Access Compliance Report

Public Rights-of-Way

| Intersection ID: 48147 | Main Street: MCCAMEY_DR | Cross Street: FRANKLIN_MEADOWS_DR | Location: SE |
| ADA ID: 4007673E0F74 | Ramp Type: Perp | Initial Pass/Fail: Fail | Overall Compliance: No |

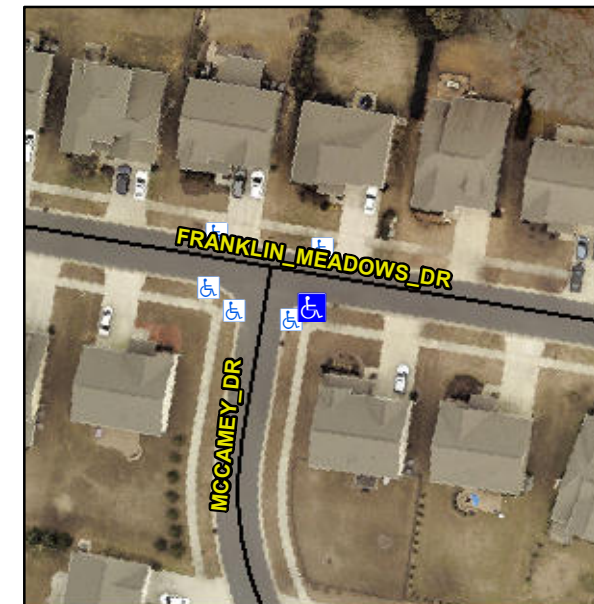
| Severity Score: 8.75 | | | |

R304.5.1

| Compliance | Description | Data | Compliance | Description | Data |
|------------|-----------------------|------|------------|-----------------------------|------|
| No | Ramp Width (in) | 47.0 | Yes | Ramp XSlope (%) | 0.5 |

Remove & Replace Entire Ramp.
